INSTRUCTIONS FOR INSTALLING THE 197751 MODIFICATION KIT
TO PROVIDE PAPER SUPPORT BRACKET FOR USE WITH PAPER OUT
ALARM ON MODEL 35 SPROCKET FEED TYPING UNIT (LP)

FIGURE 1

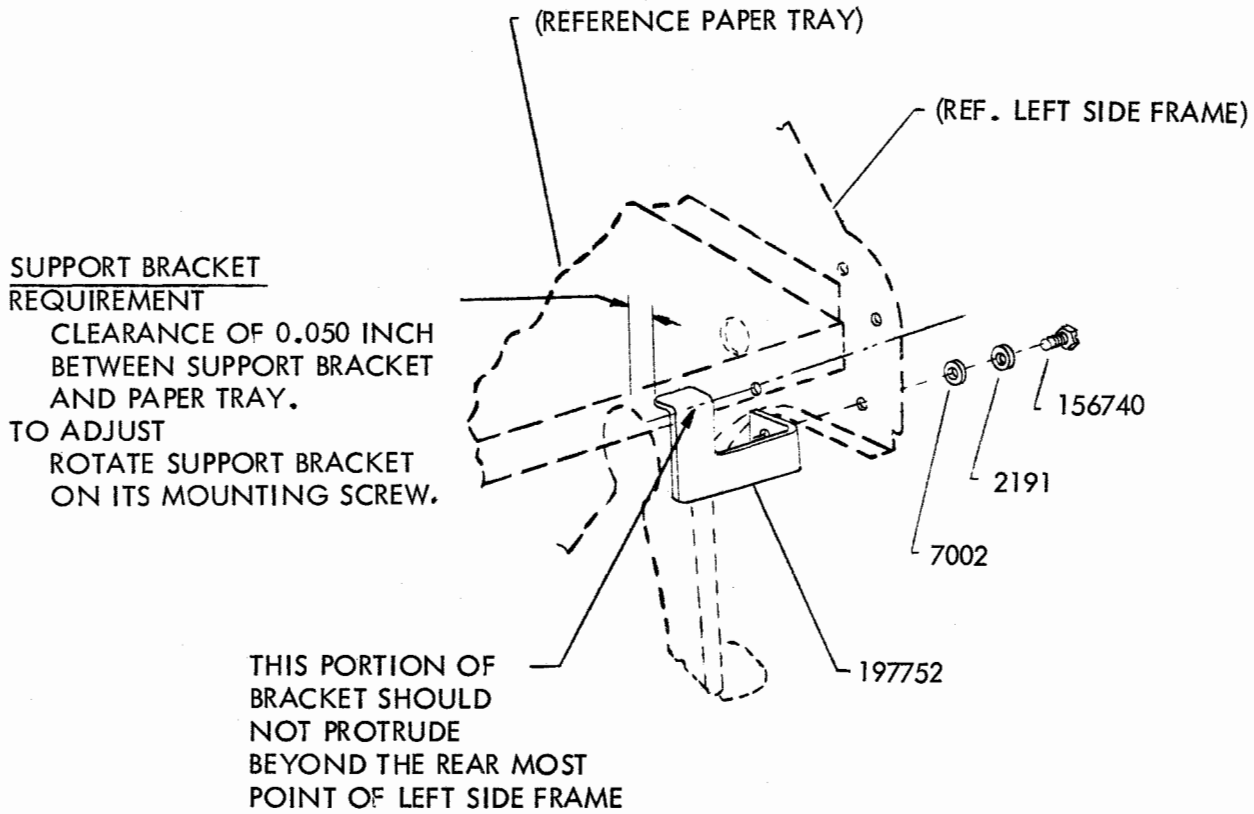
Install the 197752 Support Bracket on the left side frame (right side frame as viewed from rear of unit) with 156740 Screw, 2191 Lock Washer and 7002 Flat Washer.

b. Make the adjustment shown in Figure 1.
